Planning Response by Concerned Buderim Residents

24-26 Box St Buderim

Development Application MCU15/0270

24-26 BOX ST BUDERIM - Planning Response by concerned Buderim residents 26-3-18

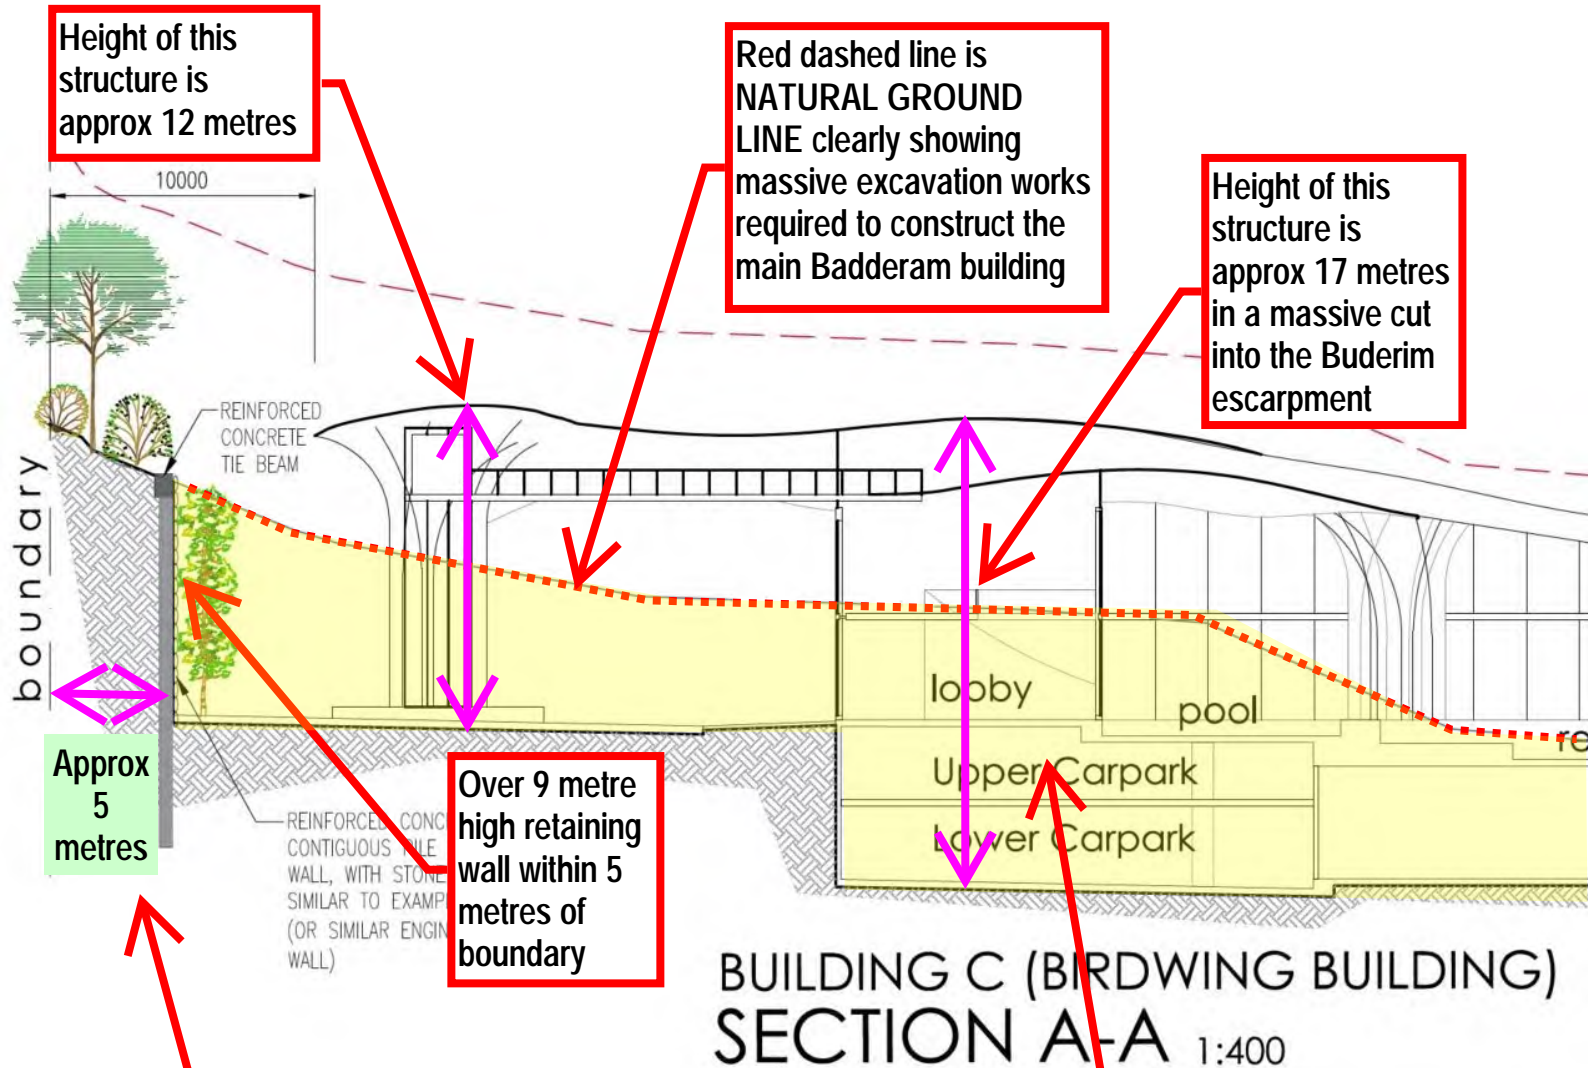
Council and Queensland Government Main Roads (as well as all the residents of Box St) are very concerned about the access to Badderam from King St (a state controlled road) into Box St, as well as down Box St to the property boundary. Unresolved road design and traffic issues include:- 1) the design of the intersection from King St into Box St; 2) potential need to relocate the bus stop to King St; 3) design detail and width of road upgrades required for Box St; 4) design detail and full resolution of turnaround to the end of Box St fronting Badderam.

This aspect of the development is so important that Council and Main Roads should insist on fully detailed "Operational Works" standard engineering drawings, as part of the development application to resolve this ABSOLUTELY CRITICAL part of the proposed development. These detailed plans should include everything from the King St intersection, down every metre of Box St to the turnaround at the Badderam boundary - and extra supporting traffic reports should be provided as necessary.

Architects Plan Birdwing Bldg Section A-A SP_BC_08 - Lodged with council Feb 2018

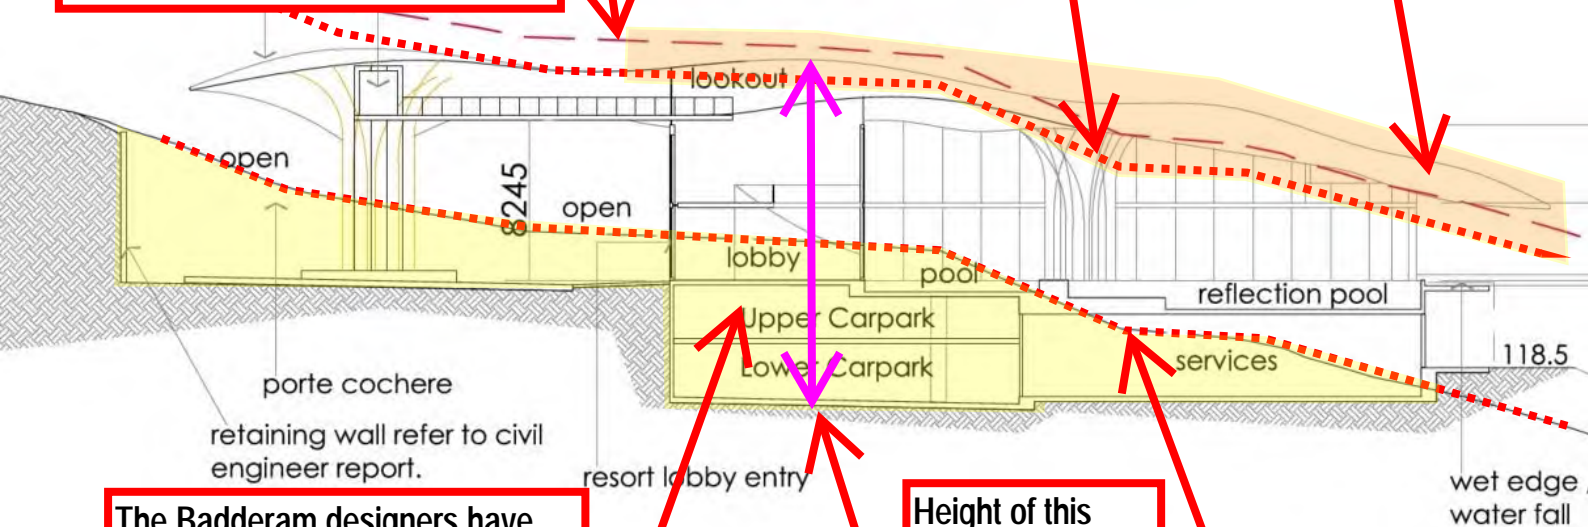
This is Badderam 10 metre height line that is on most of the plans. There is no 8.5 metre height line shown on ANY plans despite the fact council has repeatedly advised the prevailing height limit for the Buderim area is 8.5 metres would prefer buildings to be less than 8.5 metres

The 8.5 metre height limit proposed by council is shown in thicker red dashed line and clearly shows most of building height is over 8.5 metres in height from natural ground

It appears that building heights even exceed the 10 metre line Badderam has put on the plan.

The Badderam designers have relied on massive excavations into the Buderim escarpment to artificially reduce the height of buildings from "natural ground". Yellow highlighted areas shows extent of excavation into natural ground.

Height of this structure is approx 17 metres from lower basement carpark to roof

Natural ground level showing extensive cuts into Buderim escarpment

SCC Information Request to Badderam of 22-1-15 states that "The development proposes a building height beyond the maximum height for the precinct and is INCONSISTENT WITH THE CHARACTER OF THE AREA. The prevailing height for this area is 8.5 metres.

Architects Plan Type D Unit Typical South Elevation SP_TD_03 lodged council Feb 2018

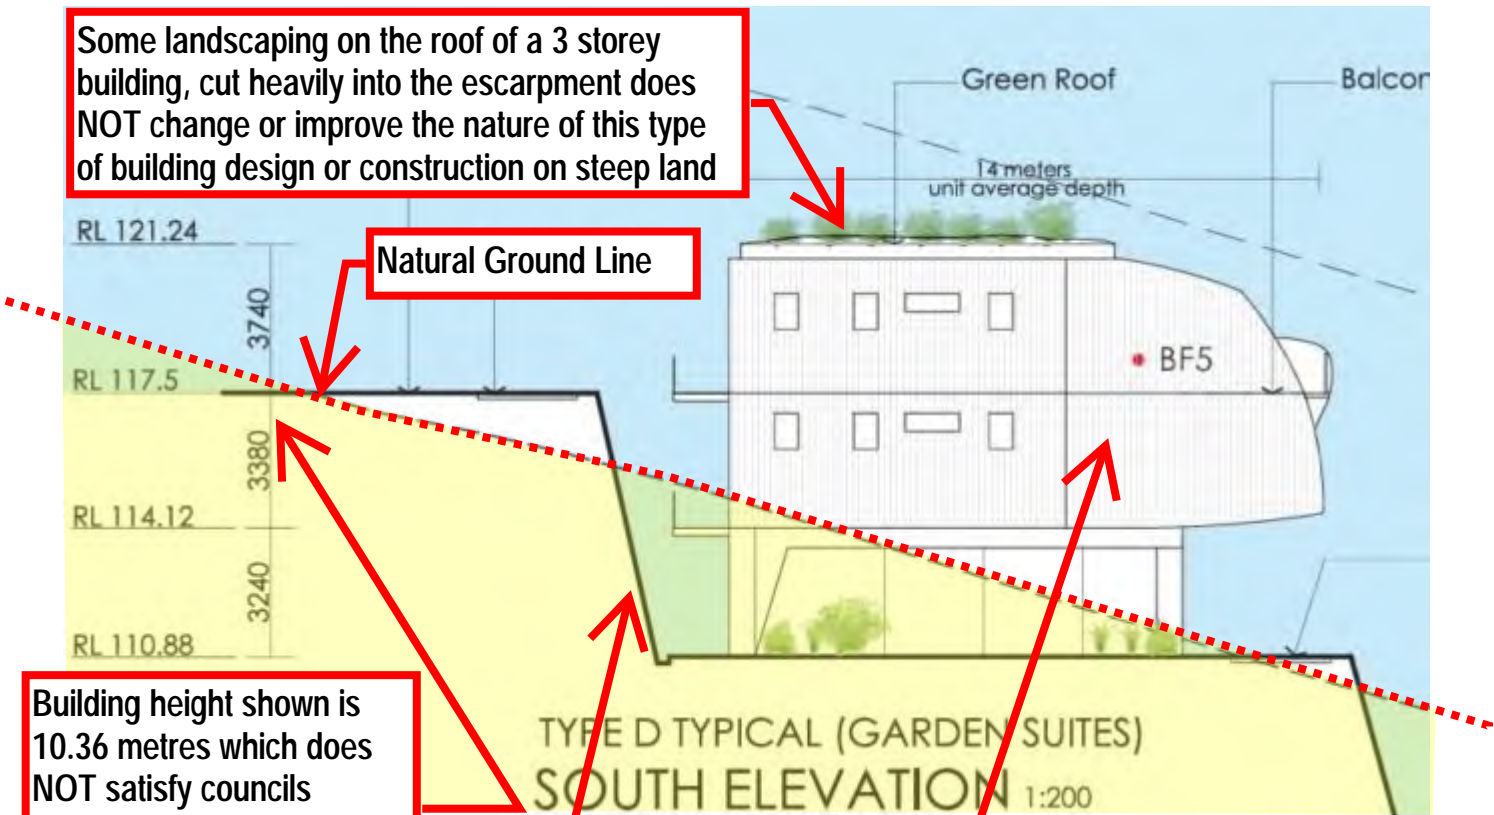
Some landscaping on the roof of a 3 storey building, cut heavily into the escarpment does NOT change or improve the nature of this type of building design or construction on steep land

Natural Ground Line

Building height shown is 10.36 metres which does NOT satisfy councils preference of 8.5 metres or the 10 metres Badderam keeps pushing for

6.6 metre high retaining wall to back of building and then more retaining to front. Extent and size of retaining walls throughout the development are excessive and are completely insensitive to the topography of the land AND the "Very Steep Land Overlay" AND the "Very High Hazard Landslide Overlay" on this site

Architects Plan Type F Typical South Elevation; Type D Typical East Elevation - Lodged with council Feb 2018

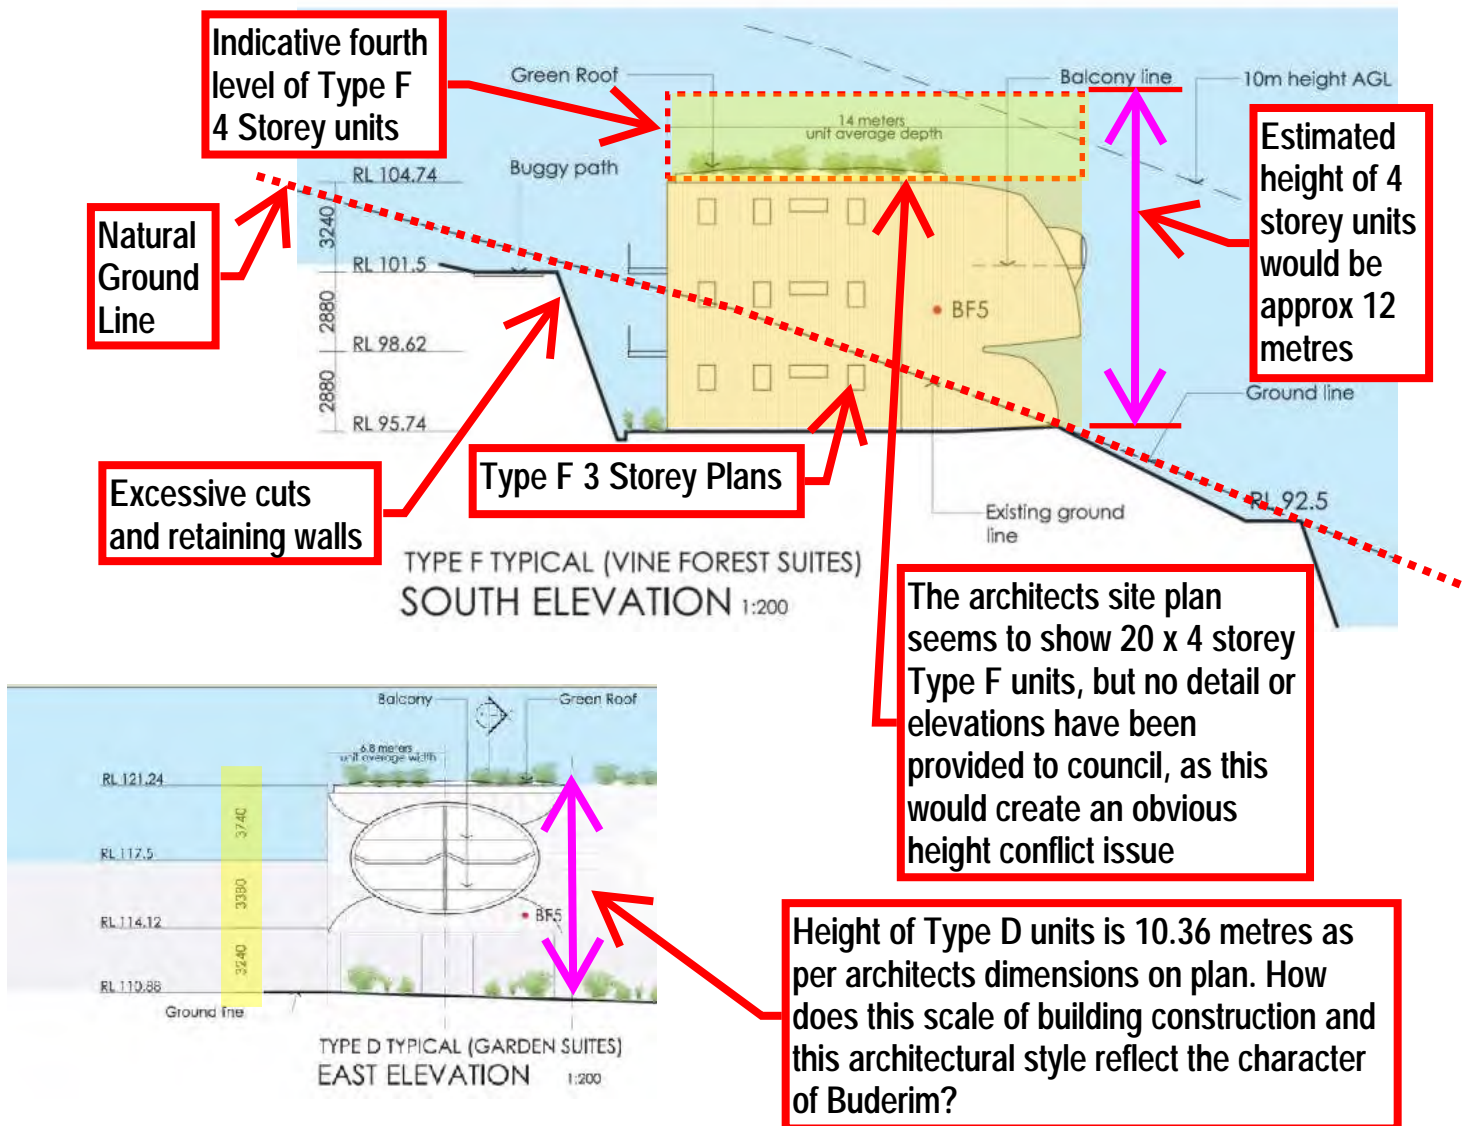
How is this architectural style in keeping with the character of Buderim?

No information provided on this retaining wall. Plans should show EVERY retaining wall on site including HEIGHT, LENGTH and a full table of ALL RETAINING WALLS ON THE SITE

"The proposed development is **INCONSISTENT** with the intent of the Buderim Non-Urban General Rural Lands precinct. The precinct does not envisage urban development and intends for buildings to be **LIGHTWEIGHT IN NATURE** and **LOCATED** and **SIZED** so that they have **MINIMAL VISUAL IMPACT**. The application **PROPOSES BUILDINGS** with a **HEIGHT, BULK AND SCALE** beyond the intent of the planning scheme and **INCONSISTENT WITH THE CHARACTER OF THE AREA**. The protection of the Buderim escarpment's vegetated character is a requirement of the planning scheme."

***The Badderam development proposal has made some changes since the application was originally lodged. The latest plans lodged to council in Feb 2018 **STILL** fail to demonstrate changes that reflect what council is **CLEARLY SEEKING** in the above statement.

Architects Plan Site Long Section of upper and lower site SP_SMP_05 - Lodged with council Feb 2018

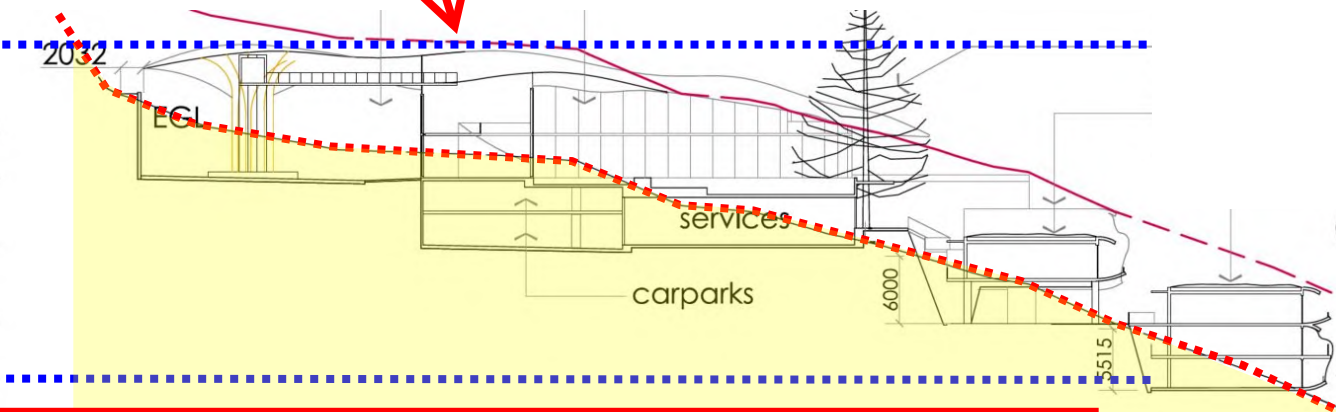
Upper site building plans show Birdwing and other buildings all stacked on top of each other from RL 105 to RL 130 which means that you will be viewing 25 metres vertically of building structures on the escarpment

SCC Outstanding Issues letter of 4-1-17 states:-
"The visual impact of the development has not been adequately addressed. The development proposes a built form exceeding the height limit of the planning scheme. The development will be CLEARLY VISIBLE FROM A NUMBER OF LOCATIONS EXTERNALLY TO THE SITE."

Approx RL is RL 130

Lower site building plans show three and four storey units all stacked on top of each other from RL 75 to RL 105 which means that you will be viewing 30 metres vertically of building structures on the escarpment.

Upper buildings of 25 metres plus lower buildings of 30 metres means that a total of 55 metres of built form will be visible vertically. This does not include the visual or physical impact horizontally of the built form, as buildings spread sideways across the site.

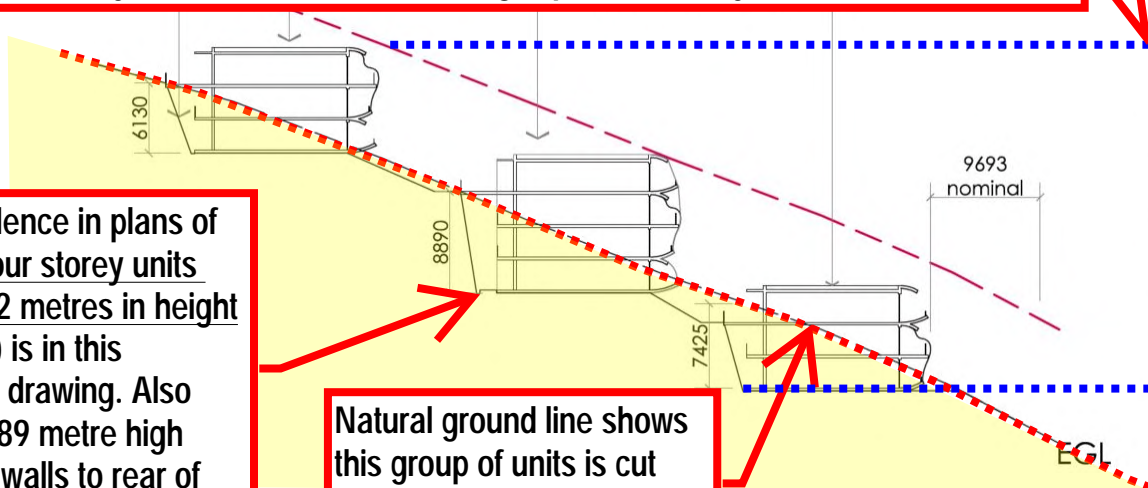
Only evidence in plans of Type F four storey units approx 12 metres in height (20 units) is in this "Section" drawing. Also shows 8.89 metre high retaining walls to rear of these units.

Natural ground line shows this group of units is cut over two storeys into Buderim escarpment
